| Project | IEEE 802.16 Broadband Wireless Access Working Group < http://ieee802.org/16 > | |
| Title | Comments on MS ranging and network entry in transparent and non-transparent mode | |
| Re: | IEEE 802.16j-07/043: "IEEE 802.16 Working Group Working Group Letter Ballot #28" | |
| Abstract | This contribution proposes to correct and merge the paragraphs in MS ranging and network entry in both transparent and non-transparent mode. | |

Figure 1 Response latencies for using RNG-REQ and MR_Code-REP

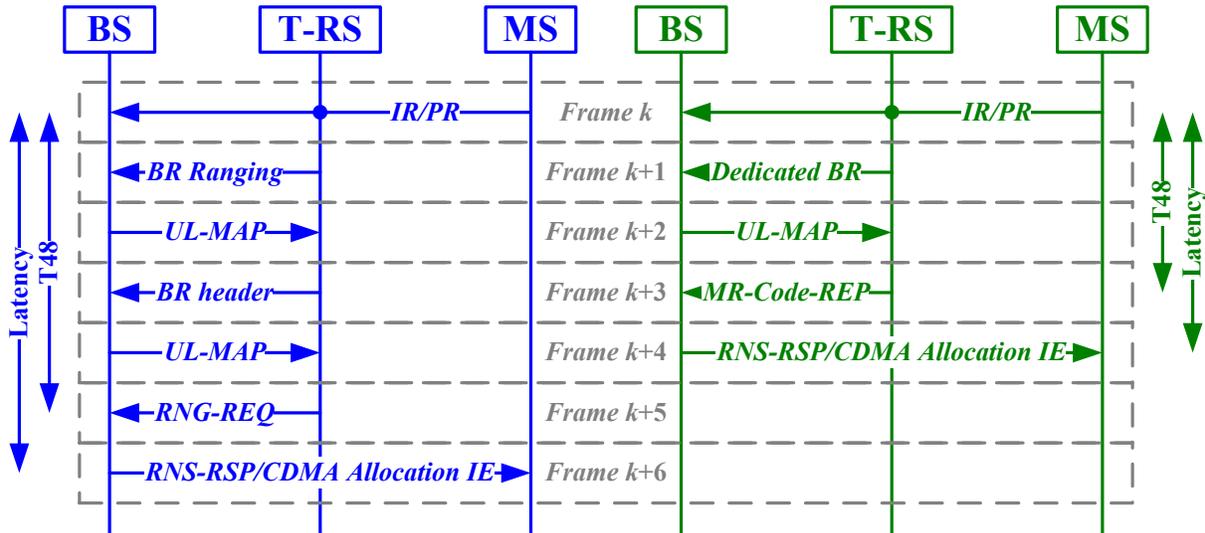
The response latency and message size of using RNG-REQ and MR_Code-REP are described in Figure 1 and Table 1, respectively. In the left side of Figure 1, the value of T48 must be at least 5 frames (25 ms for 5-ms frame). The MR-BS should allocate at least 41 bytes for RS sending RNG-REQ message and will send RNG-RSP (or CDMA allocation IE) at the 6th frame after MS sends initial ranging code. Thus, the minimum latency of initial or periodic ranging is 30 ms for 5-ms frame. In the right side of Figure 1, the value of T48 must be at least 3 frames (15 ms for 5-ms frame). MR-BS should allocate at least 26 bytes for RS sending MR-Code-REP message and will send RNG-RSP (or CDMA allocation IE) at the 4th frame after MS sends initial ranging code. Thus, the minimum latency of initial or periodic ranging is 20 ms for 5-ms frame. In summary, response latency and message size for using MR_Code-REP are less than those for using RNG-REQ.

Figure 2 Response latencies of 2-hop and 3-hop scenarios

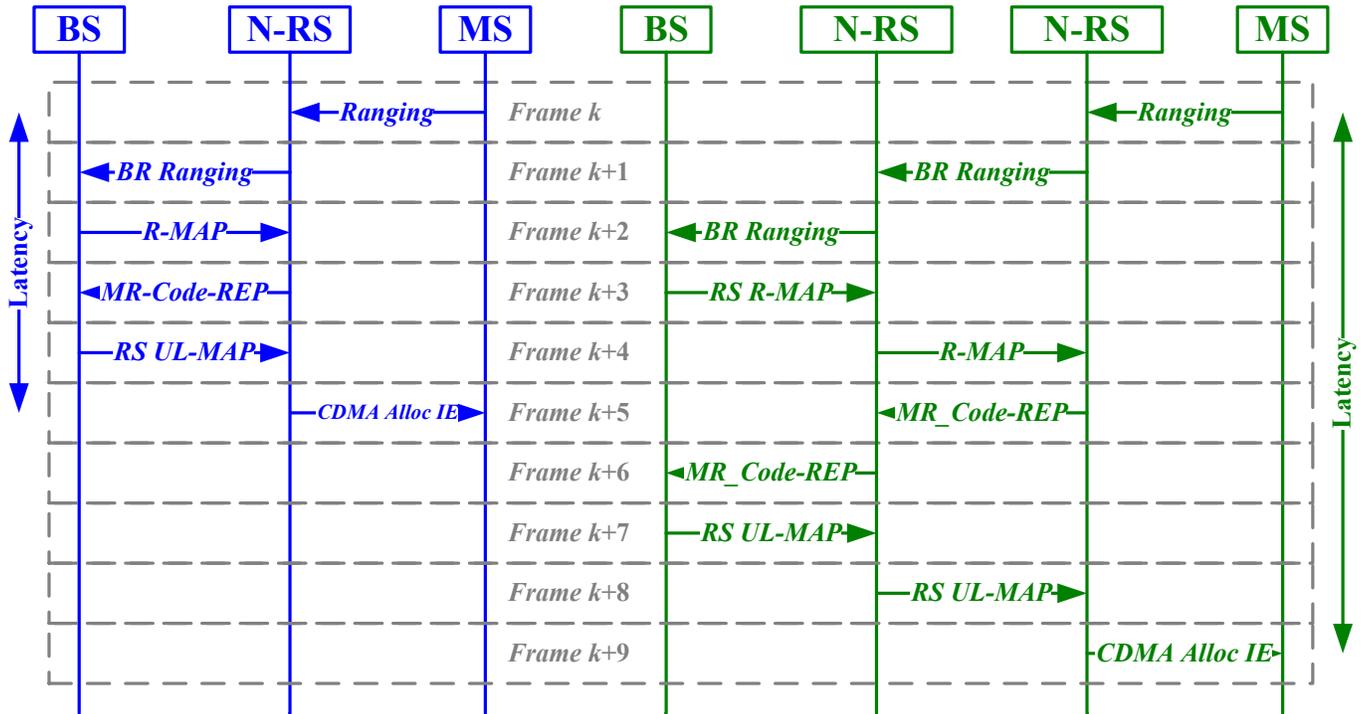
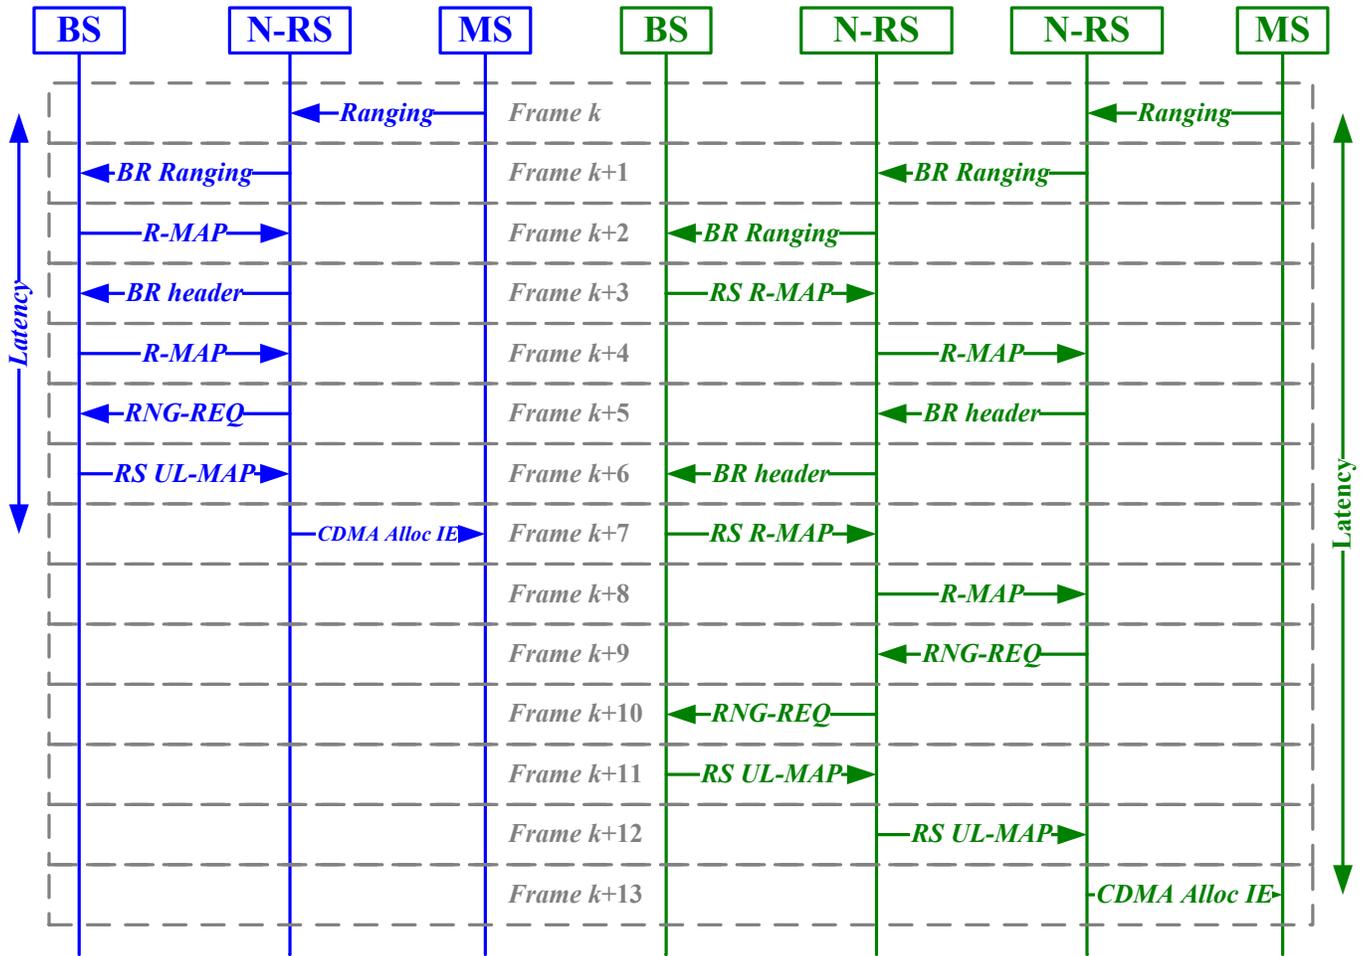
The message size and response latency of using MR_Code-REP header and RNG-REQ message are described in Table 2 and Figure 2, respectively. The minimum latencies of 2-hop and 3-hop scenarios using RNG-REQ message are 7 and 13 frames (35 ms and 65 ms for 5-ms frame), respectively. Hence the latency using RNG-REQ message in 3-hop scenario becomes unacceptable since the T3 timer (60 ms for initial or periodic ranging) at MS side has already been expired. The minimum latencies of 2-hop and 3-hop scenarios using MR_Code-REP header are 5 and 9 frames (25 ms and 35 ms for 5-ms frame), respectively. In summary, the response latency and message size for using MR_Code-REP header are less than response latency and message size for using RNG-REQ message. The comparison of response latency of using MR_Code-REP header and RNG-REQ message are described in Table 3.

Figure 3 Response latency and T48 timer for using RNG-REQ message

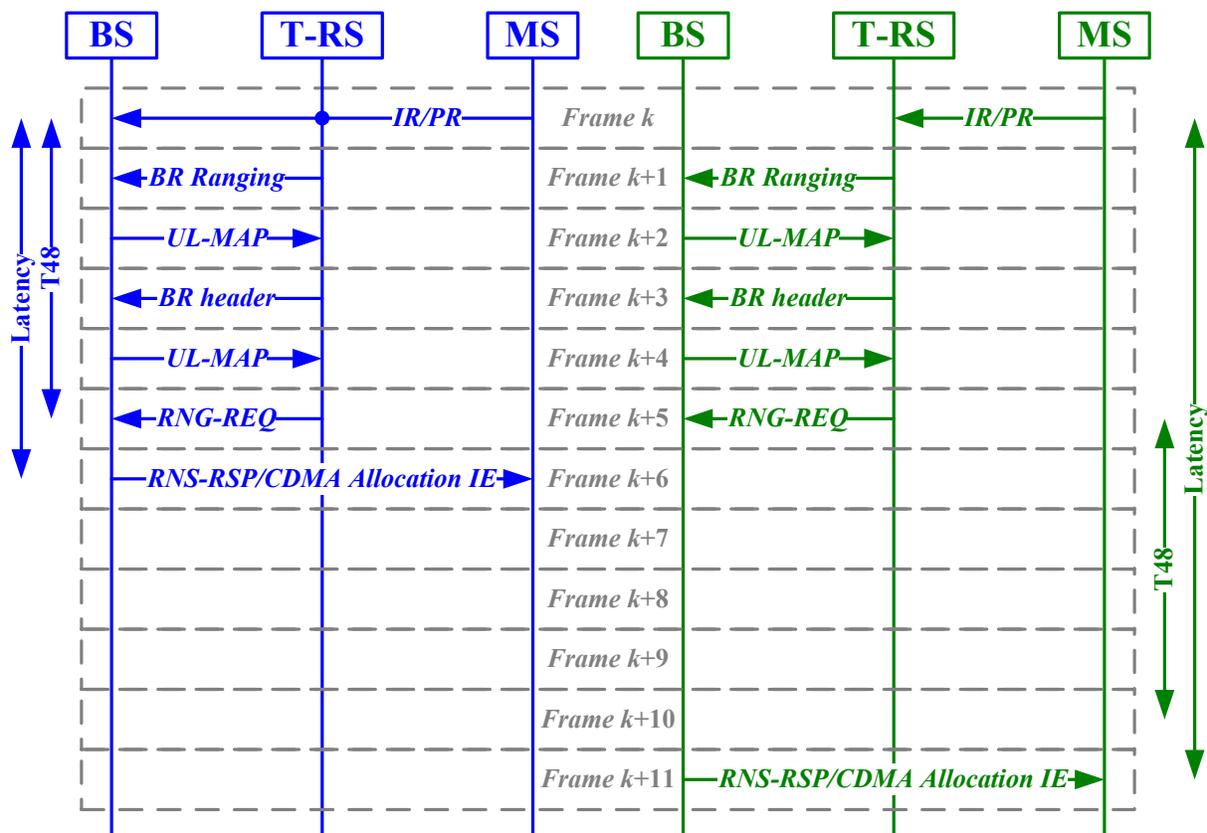
For example, in an indirect scenario described in the right one of figure 3 with T48 set to 5 frame (25 ms for 5-ms frame), MR-BS receives the relaying MS ranging code from RS at 5th frame after MS sends initial ranging code, and then sends RNG-RSP (or CDMA allocation IE) at 11th frame. Thus, the minimum latency of initial or periodic ranging is 55ms. If we consider the implementation safety margin, the value of T48 is at least 6 frames (30 ms). Thus, the latency will be at least 13 frames (65 ms), which is larger than the value of T3 timer (60 ms for initial or periodic ranging). Hence, the latency becomes unacceptable since the T3 timer at MS side has already been expired. Hence, the adjusted value of T48 for the indirect scenario should be 30 ms (original T48) minus 25 ms (latency of relaying MS ranging code).

Figure 4 Latencies during the ranging procedure for 2-hop and 3-hop scenarios

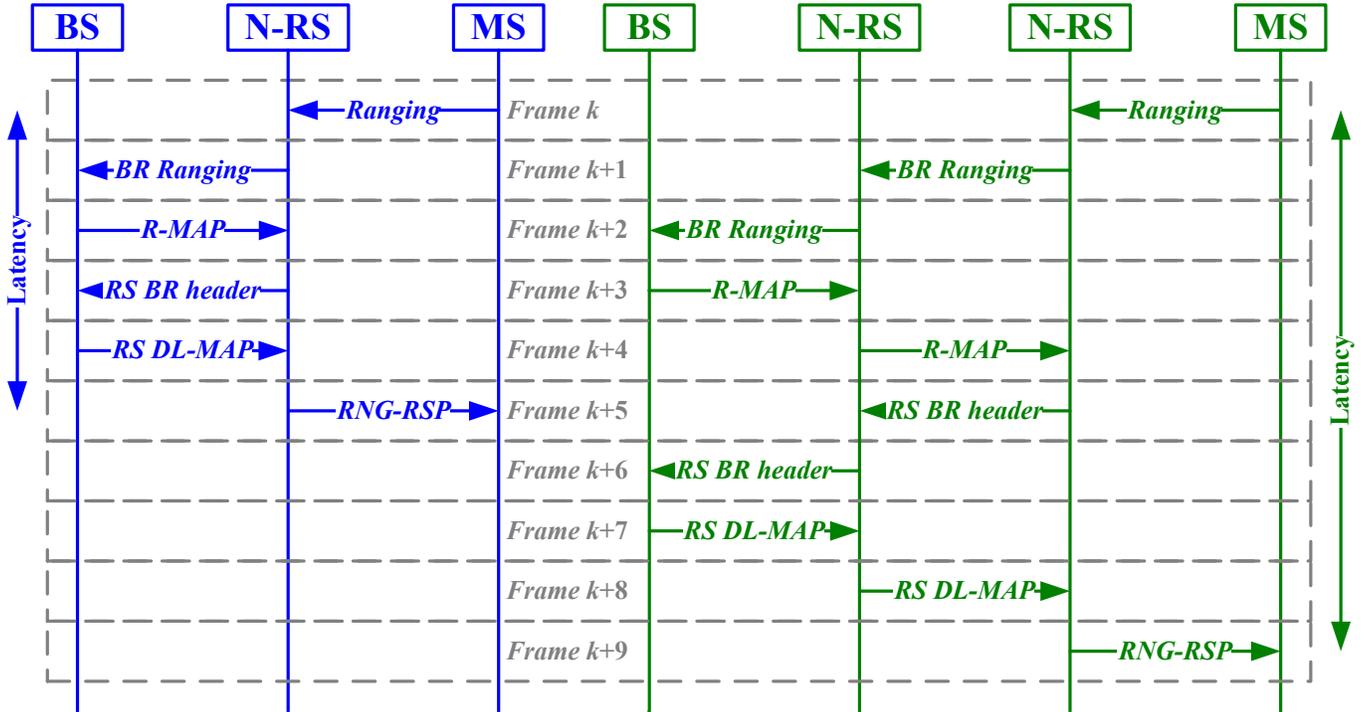
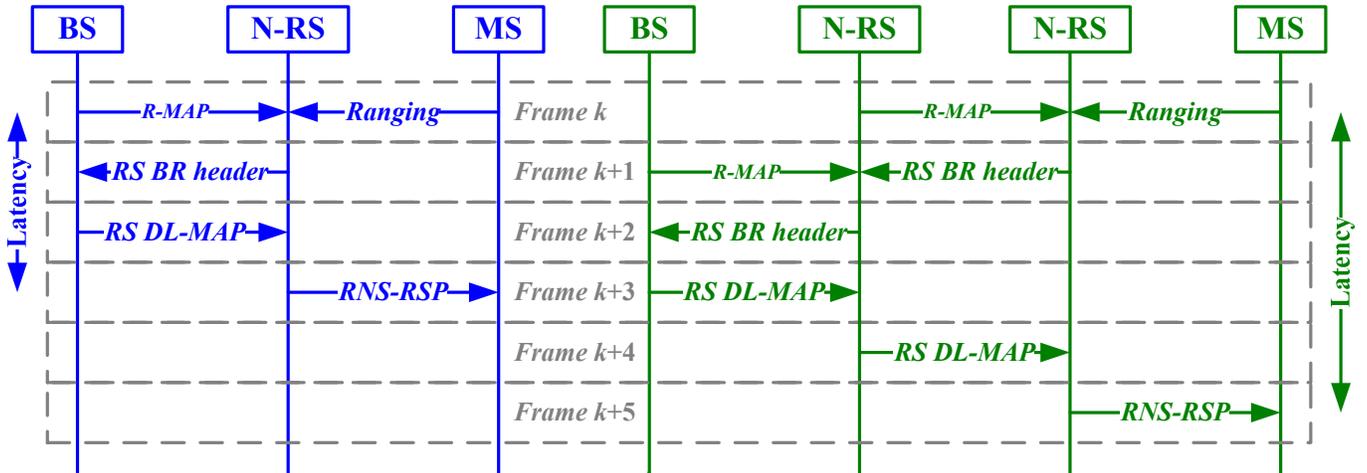
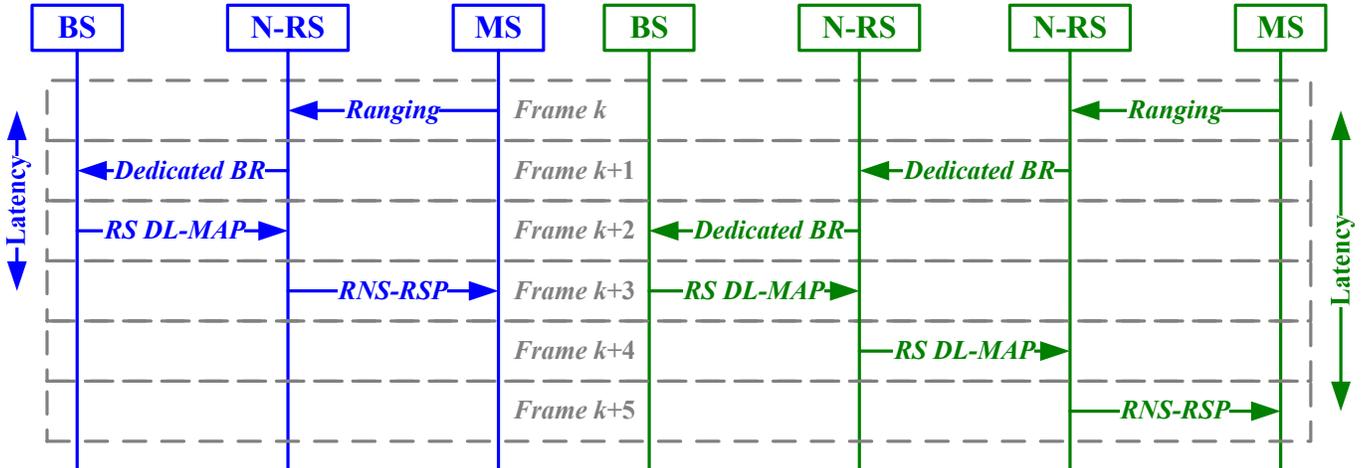
The response latencies for using anonymous ranging code for sending RS BR header (to request bandwidth to send RNG-RSP), using dedicated uplink bandwidth for sending RS BR header, and using dedicated ranging code for sending RNG-RSP are described in Figure 4. In Figure 4, the minimum latency of CDMA ranging response for 2-hop and 3-hop are 5 and 9 frames (25 and 45 ms for 5-ms frame). Furthermore, the minimum latency with hop-count more than four is larger than 13 frames (65 ms for 5-ms frame) and becomes unacceptable since the T3 timer (60 ms for initial or periodic ranging) at MS side has already been expired. The comparisons of response latency are described in Table 4. In order to resolve this issue, we recommend using Feedback Polling IE or dedicated ranging code to shorten the latency (see Figure 1b and 1c), where the minimum response latency for 2-hop and 3-hop scenario are 3 and 5 frames (i.e., 15 and 25 ms for 5-ms frame), respectively.

Figure 112a—Handling CDMA ranging code at a transparent RS

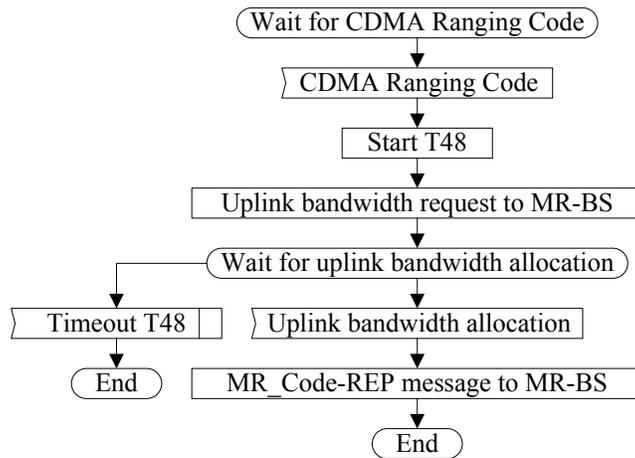
[Merge Figure 95 with, Figure 108a and Figure 108h; then move it to here as following indicated:]

Figure 112b—Handling CDMA initial ranging code at a non-transparent RS with different preamble under centralized scheduling

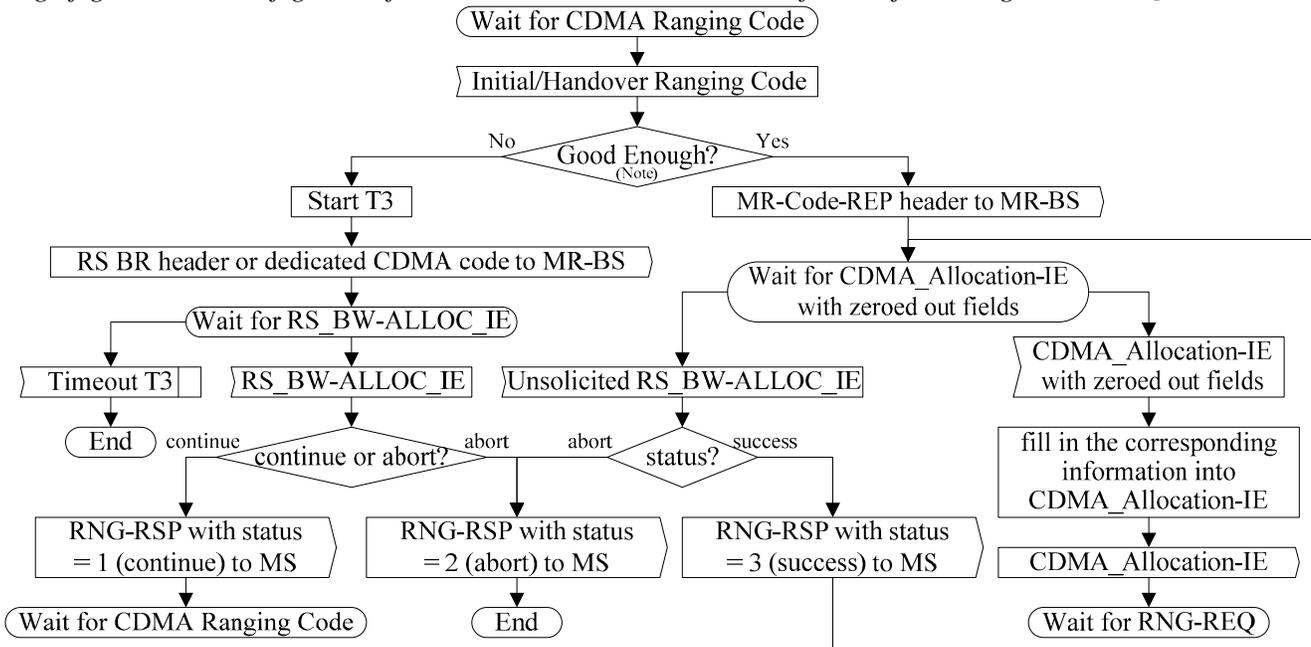
[Merge figure 95e with figure 95f, then move it to here, and modified as following indicated:]

Figure 113a—Handling CDMA ranging code or MR Code-REP message at an MR-BS

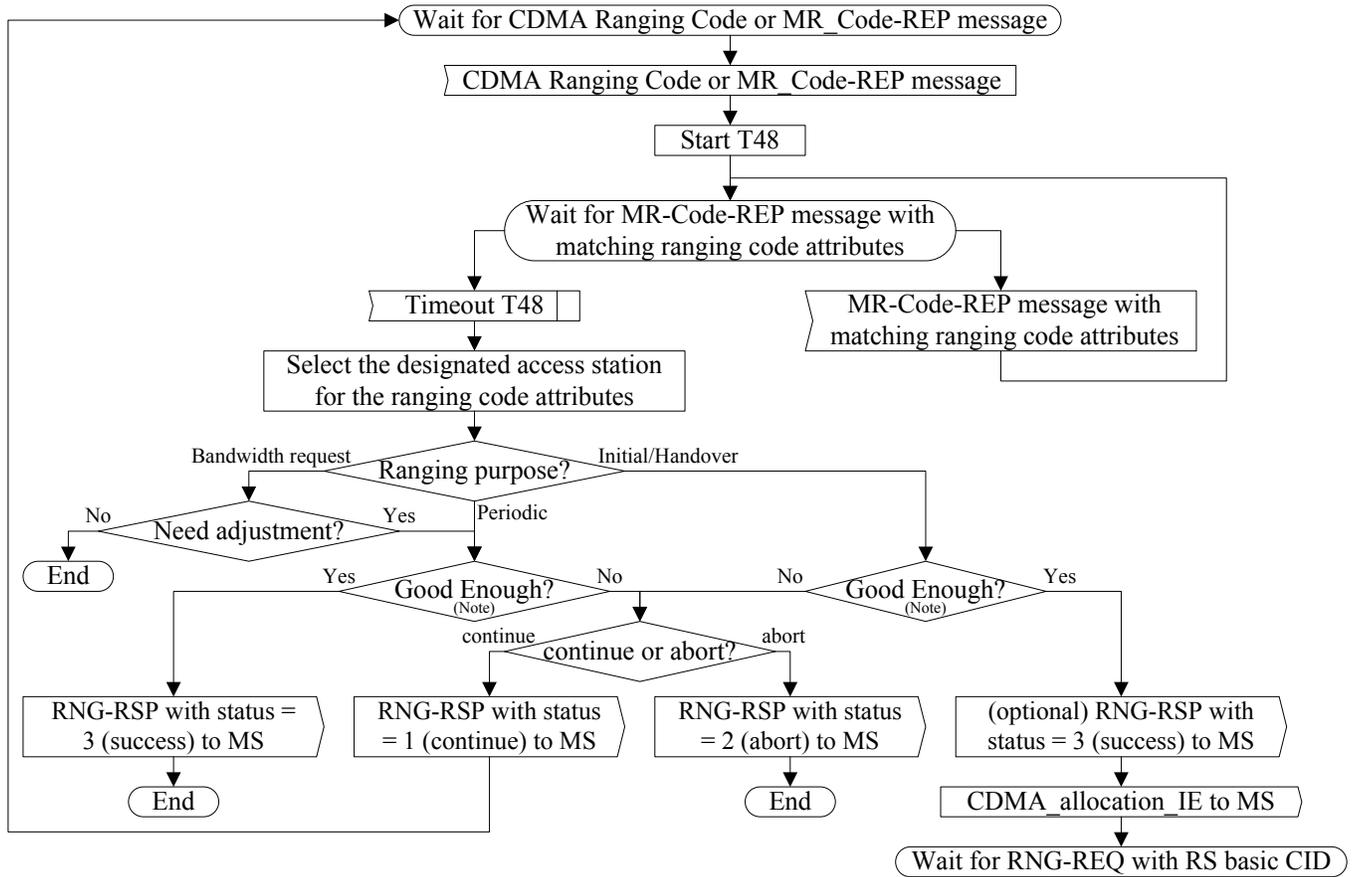
[Merge Figure 95c with Figure 108b and Figure 108i; then move it to here as following indicated:]

Figure 113b Handling MR Code-REP at MR-BS

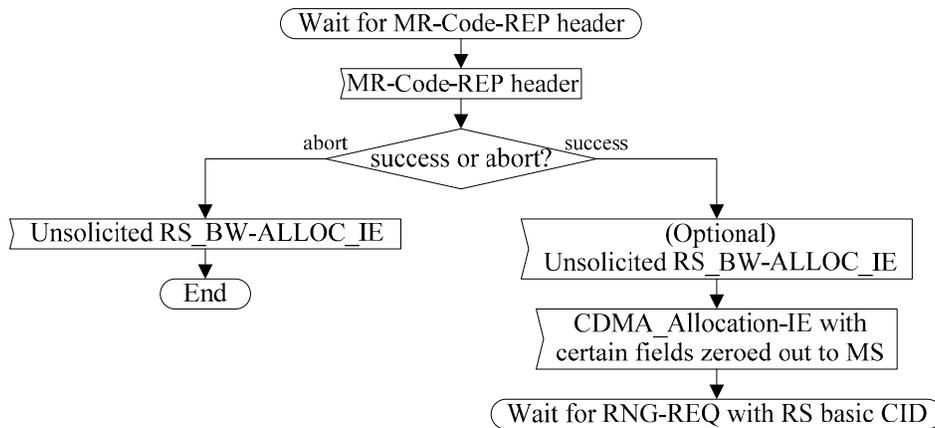
[Move Figure 95h to here, and modified it as following indicated:]

Figure 113c—Handling RNG-REQ at a transparent RS

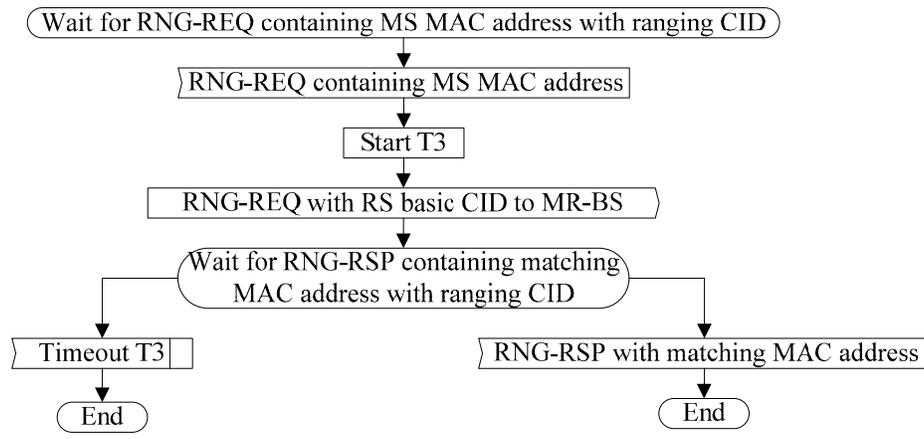
[Move Figure 95b to here and modified it as following indicated:]

Figure 113d—Handling RNG-REQ at a non-transparent RS

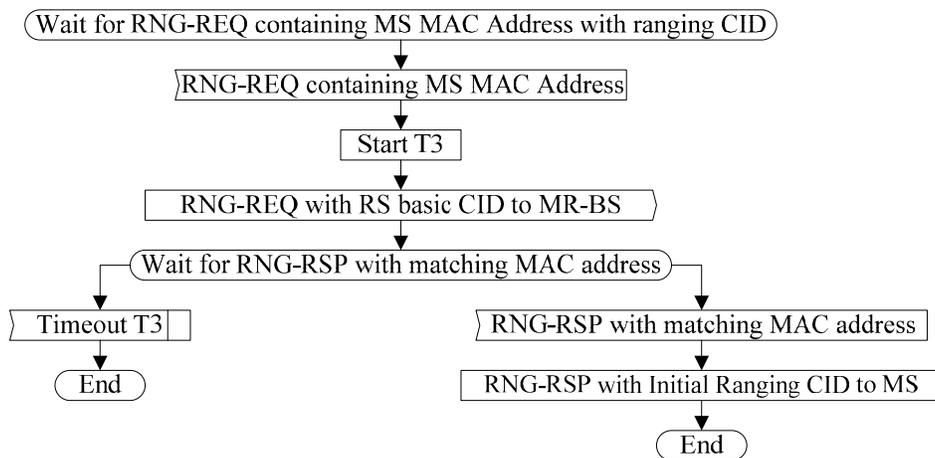
[Move Figure 95g to here, and modified it as following indicated:]

Figure 116a—Handle Handling RNG-REQ at an MR-BS

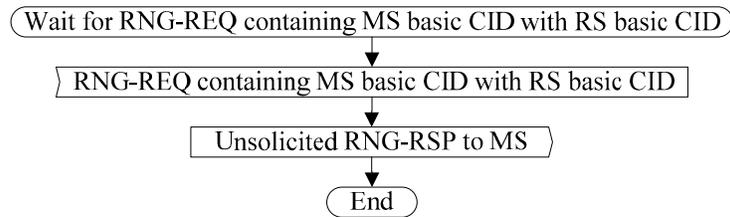
[Move Figure 108f and modify it as following indicated]
